Depleted 12V Auxiliary Battery

YEAR(S)	MODEL(S)	ADDITIONAL INFORMATION
2021	RAV4 Prime

Some 2021 model year RAV4 Prime vehicles may exhibit a depleted 12V auxiliary battery when in IG-OFF due to a condition in which the Hybrid Vehicle Electronic Control Unit (HV ECU) does not sleep. The HV ECU may not sleep if any of the following conditions have occurred with the vehicle:

Figure 1. Location of Authorized Modifications Label on 2021 RAV4 Prime

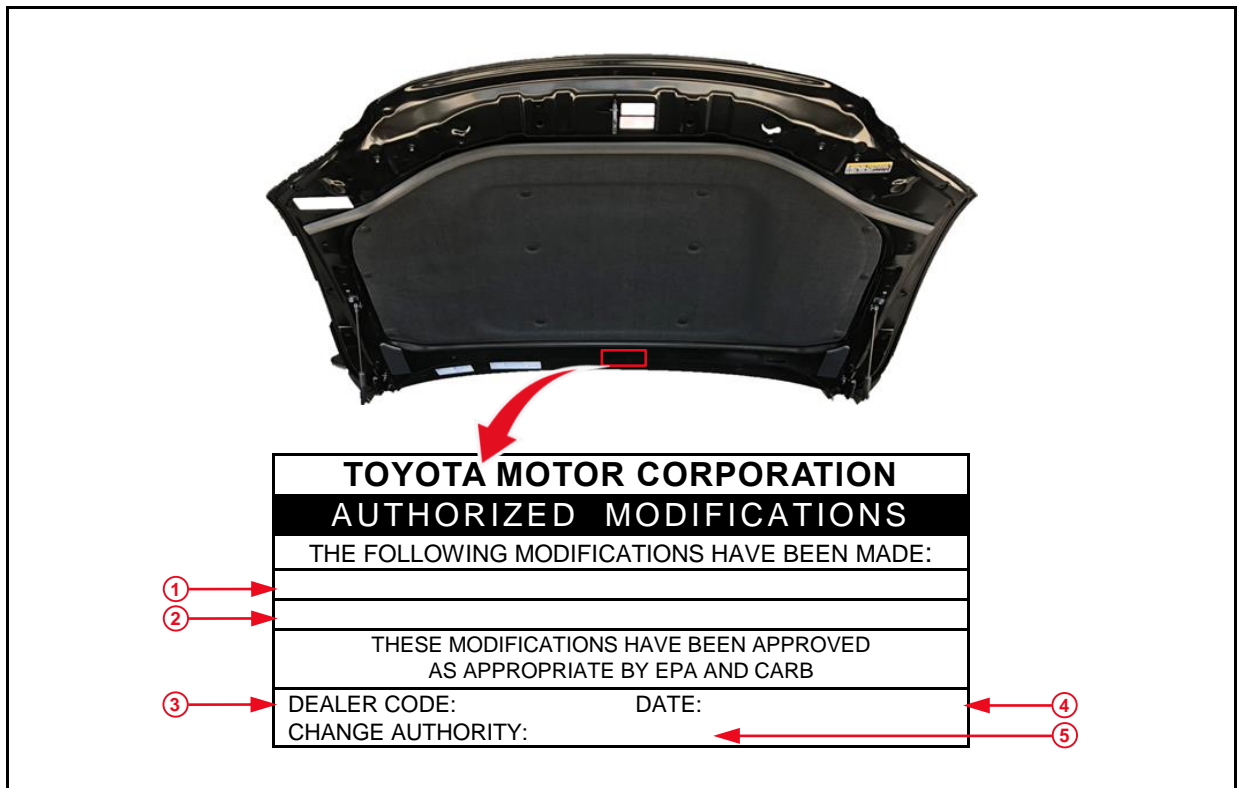
- Use Techstream to confirm if the HV ECU calibration has been updated and check for the Authorized Modifications Label affixed to the vehicle in the location shown below.

Is the calibration ID listed in Techstream and on the label the latest HV ECU calibration?

- Prepare and install the Authorized Modifications Label.
 - Using a permanent marker, enter the following information on the label:
 - HV ECU part number [Refer to the **Parts Information** section for the **NEW PART NUMBER**]
 - Calibration ID(s) [Refer to the **Calibration Information** section for the **NEW CALIBRATION ID**]
 - Dealer Code
 - Repair Date
 - Change Authority [***This bulletin number***]
 - Install the Authorized Modifications Label onto the vehicle at the location shown in Figure 1. The Authorized Modifications Label is available through the MDC, P/N 00451-00001-LBL.
- Test-drive the vehicle to confirm proper operation.
